Aqueous Solutions (owner) AQS-MFG-AFTERBURNER-NOZZ01
AFTERBURNER fabrication drawing NOZZ01 (AQS-PLAN-006 M3; gra
Type: fabrication drawing (GA / nozzle orientation / part sheet) Rev 5c8db798 Issued
Created: flow graph pipeline Approved: not approved (study)
Sheet 1 of 1 AQS-DWG-001

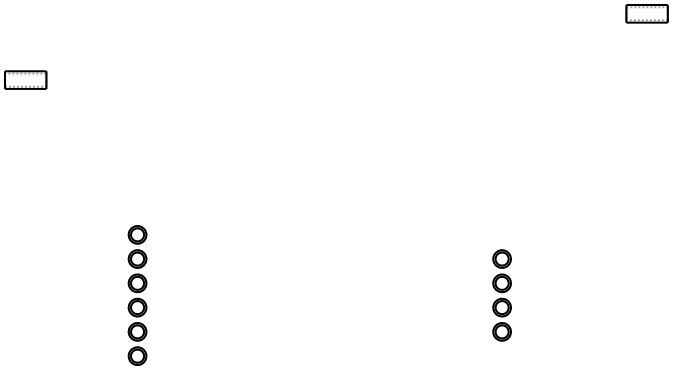
Graph revision AD - nozz01: Connection hardware DN15 as open-bore tube stubs flush at the envelope faces (lib builders); atmospheric per duty section 4
Graph revision AD - nozz01: All 12 schedule rows present at tag, face, height and bore; per-tag positions in check.nozzles_drawn
Graph revision AD - nozz01: The N12 solids row is a non-piped transfer (sealed bins to incineration, barrier 2): draw
